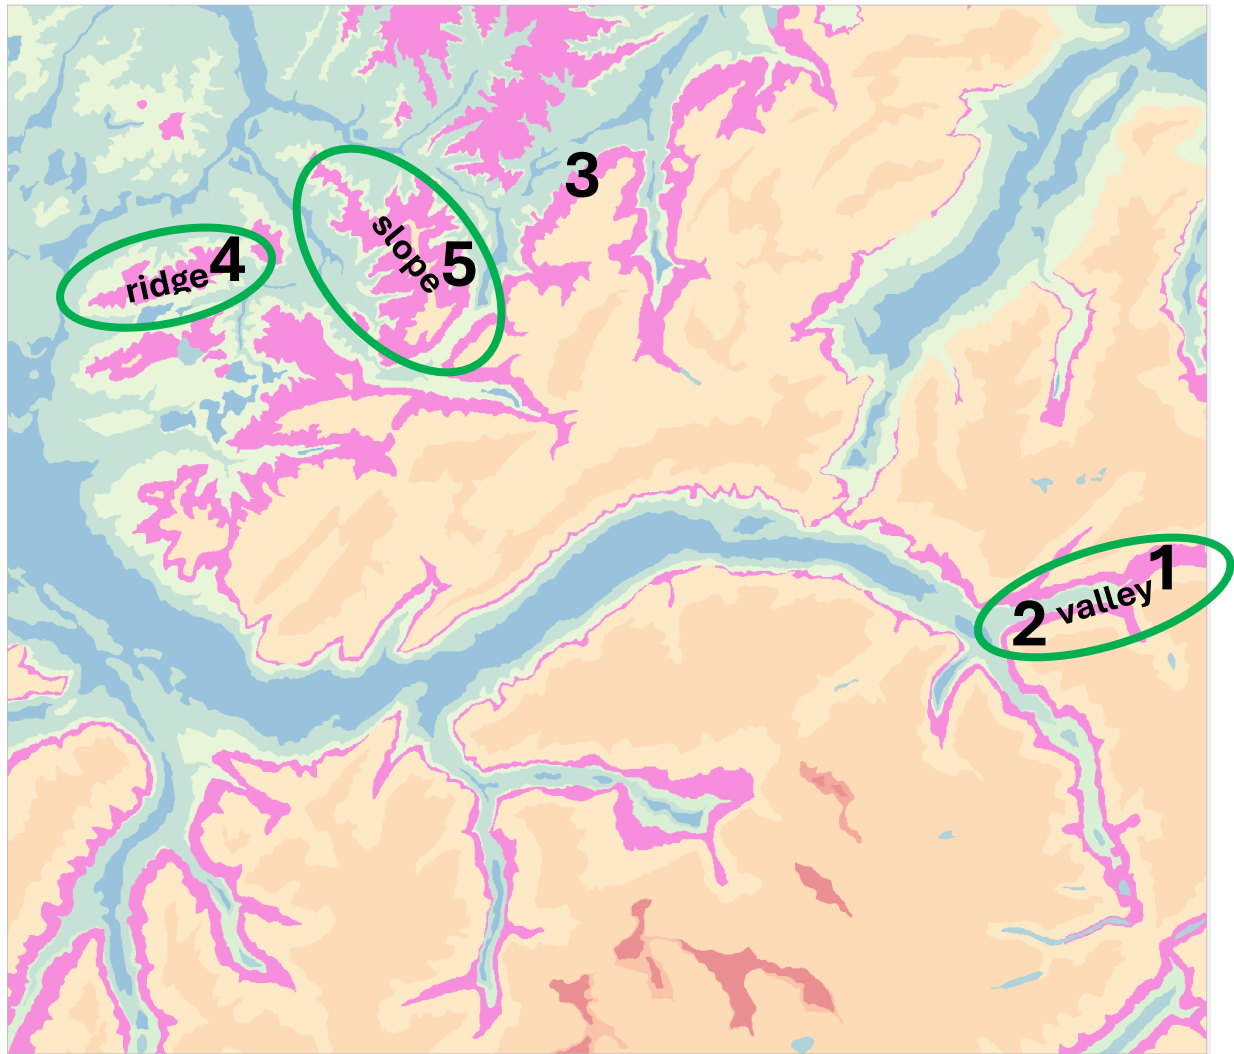
This figure from the Alps illustrates what is problematic from my point of view with the 'landform' classification proposed in the GBLU. The landform class 2.2.2. 'Middle-altitude low-relief mountain slope', highlighted in purple, identifies lower slopes or valley bottoms (concave shapes) in the Alps while it identifies ridges (convex shapes) in the alpine foreland. Then, there is an intermediate case where 2.2.2. seems to correspond to mid-slopes of ridges. Ontologically, morphologically, visually and genetically these landforms have very little in common, apart from a certain elevation and slope class. Basically, depending on where you look on the map class 2.2.2. is either a high mountain valley floor (1), a high mountain valley slope (2), a high mountain foot slope (3), a low mountain crest or ridge (4), or a low mountain slope (5).
